Access Compliance Report

Public Rights-of-Way (Curb Ramps)

Intersection ID: 48283	Main Street: MEADOWMONT_VIEW_DR	Cross Street: MEADOWMONT_VIEW_DR	Location: NE
ADA ID: 5313FF74533F	Ramp Type: PerpDiag	Initial Pass/Fail: Fail	Overall Compliance: No
Severity Score: 8.75			
Codes/Mitigation Info/Possible Solution		Field Measurements/Component Compliance

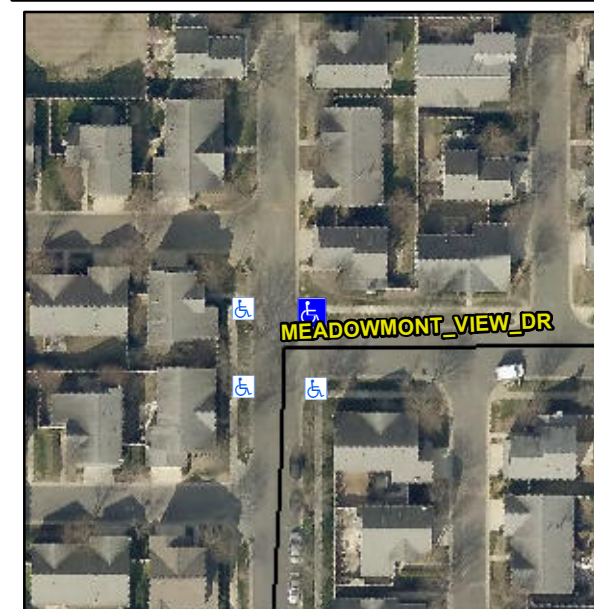
Not Found, R304.5.1

Compliance	Description	Data	Compliance	Description	Data
N/A	Ramp Length (in)	72.0	Yes	Ramp Slope (%)	7.8
No	Ramp Width (in)	42.0	Yes	Ramp XSlope (%)	0.2
N/A	Flare Type LT	N/A	N/A	Flare Type RT	N/A
N/A	Flare Slope LT (%)	N/A	N/A	Flare Slope RT (%)	N/A
N/A	Flare Traversable LT?	N/A	N/A	Flare Traversable RT?	N/A
N/A	Landing Length (in)	N/A	N/A	DWS Provided?	N/A
N/A	Landing Width (in)	N/A	N/A	DWS Contrast?	N/A
N/A	Landing Slope (%)	N/A	N/A	DWS Length (in)	N/A
N/A	Landing X Slope (%)	N/A	N/A	DWS Full Width?	N/A
N/A	Landing Curb? (Y/N)	N/A	N/A	DWS Offset (in)	N/A
N/A	Shared Landing?	N/A			
N/A	Gutter Ponding?	N/A	N/A	Gutter Slope (%)	N/A
N/A	Gutter Lip Ht (in)	N/A	N/A	Gutter X Slope (%)	N/A
N/A	Painted X Walk1?	No	N/A	Painted X Walk2?	No
	X Walk 1 Direction	To W		X Walk 2 Direction	To S
N/A	X Walk 1 Width (in)	N/A	N/A	X Walk 2 Width (in)	N/A
	X Walk 1 Slope (%)	0.2		X Walk 2 Slope (%)	0.2
	X Walk 1 X Slope (%)	1.5		X Walk 2 X Slope (%)	1.1

Remove & Replace Curb Ramp With Two New Directional Ramps or Equivalent.
